TECHNICAL BULLETIN

Headlamp Misting –
Improve Ventilation –
Repair Procedure

MODEL
1997-2004 MY
XK Range
VIN
001001-A39841

Remove and destroy Bulletin 417-05 dated 12/01.
Replace with this Bulletin.
Revisions are marked with a bar and in **bold text**.

ILLUSTRATION 1

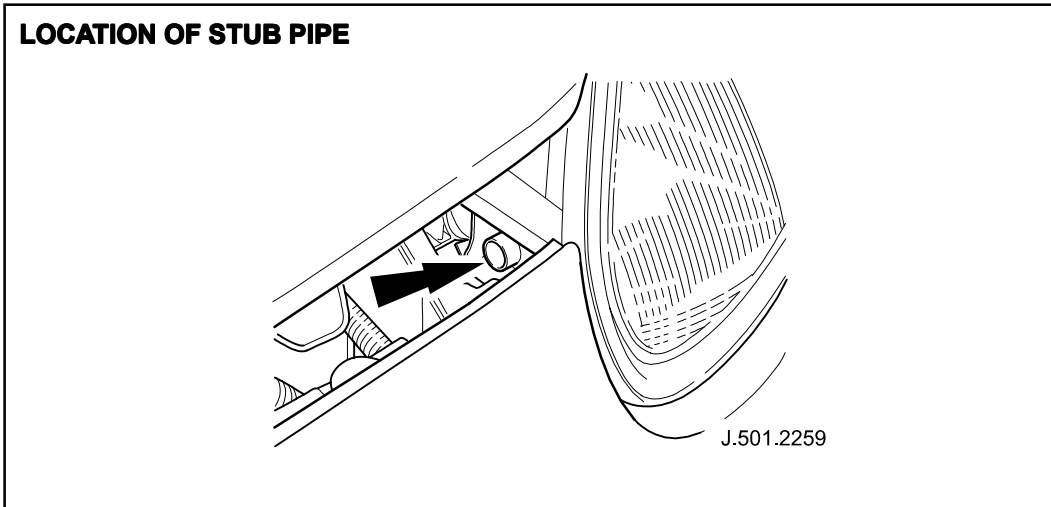
1. Inspect headlamp to see if stub pipe is present (Illustration 1).

Note: If stub pipe is present, continue with workshop procedure from step 2, if stub pipe is not present, obtain a new headlamp assembly and continue from step 3.

ILLUSTRATION 2

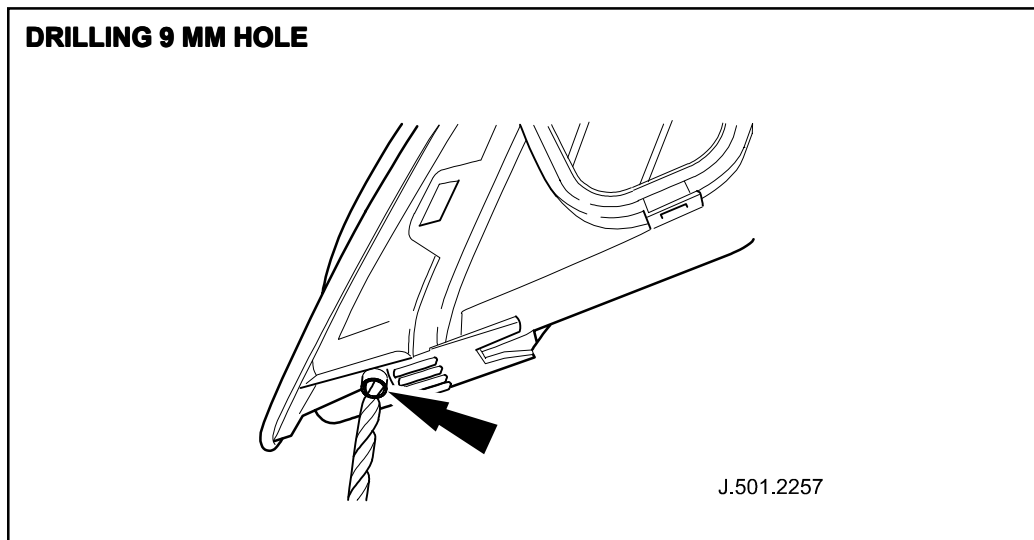
4. Carefully drill a 9 mm diameter hole upwards into headlamp using the stub pipe as a guide (Illustration 2).

Note: Maintain headlamp in the same orientation as for the drilling operation and shake out any drilling debris ensuring none remains in the headlamp.

ILLUSTRATION 3

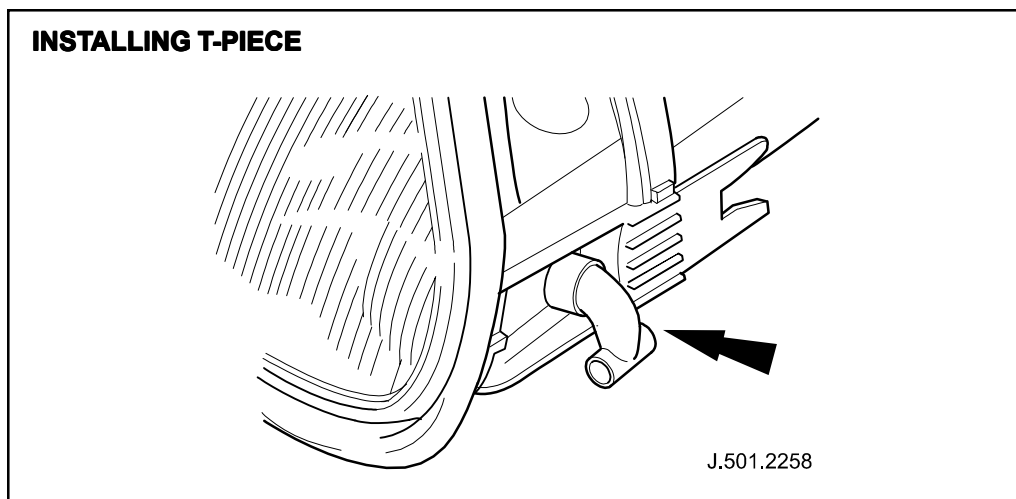
5. Place headlamp on clean bench.
6. Install and align T-piece to stub pipe (Illustration 3).

Note: Ensure headlamp stub pipe and T-piece mating surfaces are free from oil and grease.
